1 BACKGROUND:

- 1.1 Entel are upgrading their HX LCD display to a "Type 2" display (HT radios are not affected).
- 1.2 A new Bootloader and the latest firmware **MUST** be installed once the LCD is fitted (see below).
- 1.3 For instructions on "How To Update The Software For A Type 2 LCD" see www.entel.co.uk.

3 IDENTIFICATION:

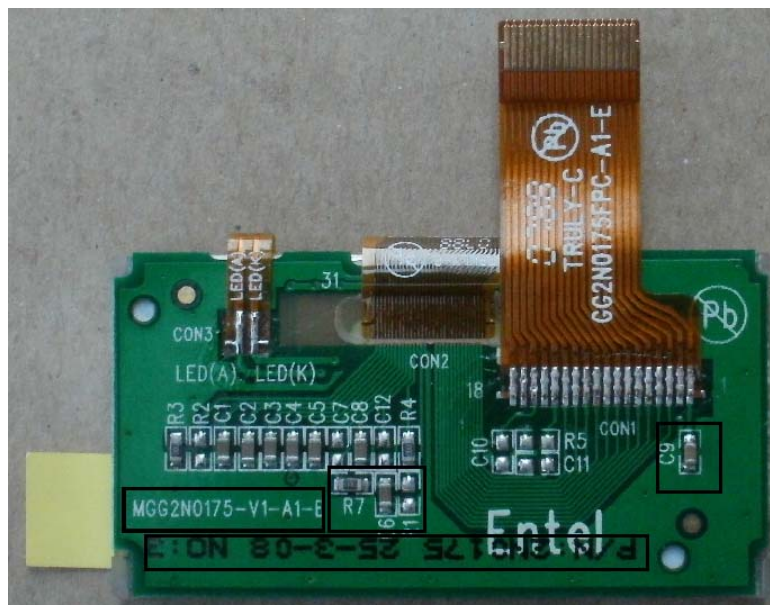
Type 1 – Existing LCD Display

Type 2 – New LCD Display

- 2.1 After fitting a Type 2 LCD please install the latest Bootloader (HX_TYPE2_LCD_ONLY_BOOTLOADER.fw).
- 2.2 Update the Firmware – Please download and install the latest firmware into the radio.

Please Note: Please reuse or replace the two rear LCD cushions (part no. 9403040510A) as these act as an insulator.
